**Re: Progress Report No. 17, District on the River Redevelopment
November 2022**

Sagamore Spokane, LLC; PPCD No. 21200059-32
Facility/Site ID #1523145 and Cleanup Site ID #3509
Project No. 190210

**Foundation Plan Markups
of Test Helical Piles S-101**

LEVEL 01 FOUNDATION PLAN

LEVEL 01 FOUNDATION PLAN
SCALE: 3/32" = 1'-0"

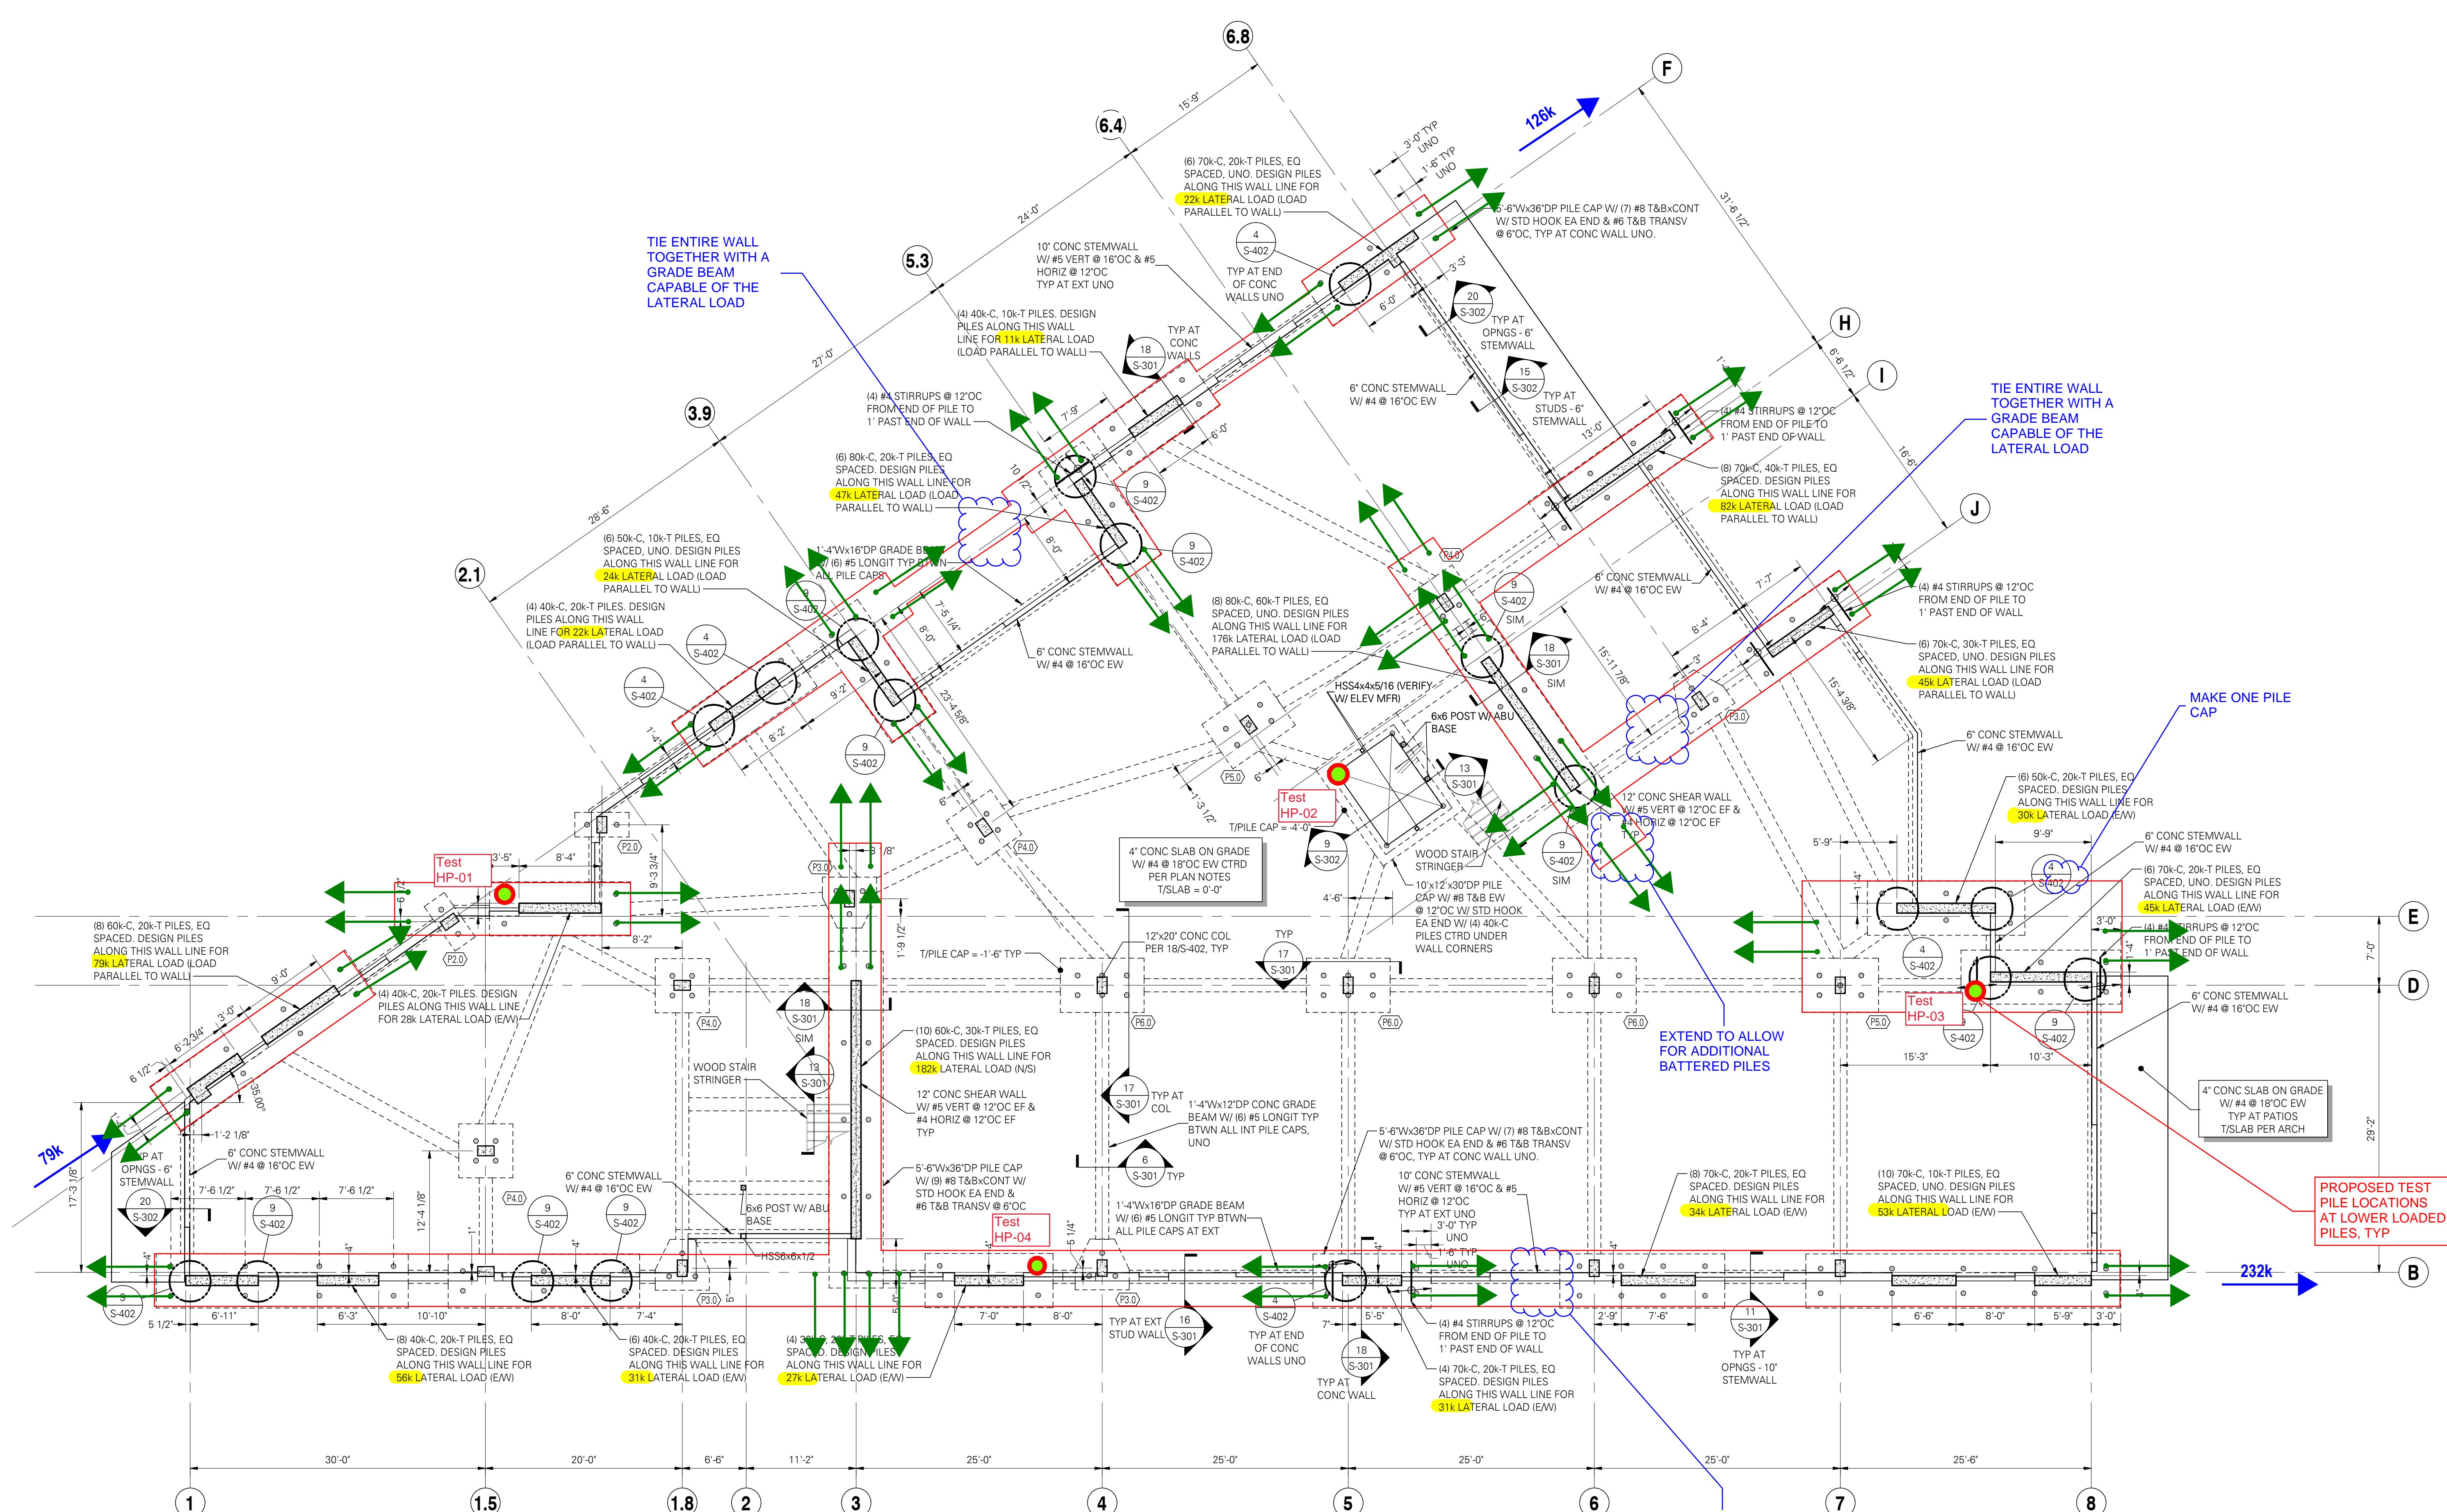
5-6 TEST PILES

PROPOSED TEST PILE LOCATIONS AT LOWER LOADED PILES, TYP

SHOULDN'T HAVE A PROBLEM HERE BUT LOCATE THEM SO THEY ARE BETWEEN P4.0 PILES CAPS

MAYBE THIS ONE IS THE LAST ONE TESTED AND IF THE OTHER PILES ARE STRUGGLING TO GET TO THE DESIGN LOADS, THIS ONE WOULD BE PUT IN BETWEEN COLUMNS AND BE SACRIFICIAL

MAYBE THIS ONE IS THE LAST ONE TESTED AND IF THE OTHER PILES ARE STRUGGLING TO GET TO THE DESIGN LOADS, THIS ONE WOULD BE PUT IN BETWEEN COLUMNS AND BE SACRIFICIAL
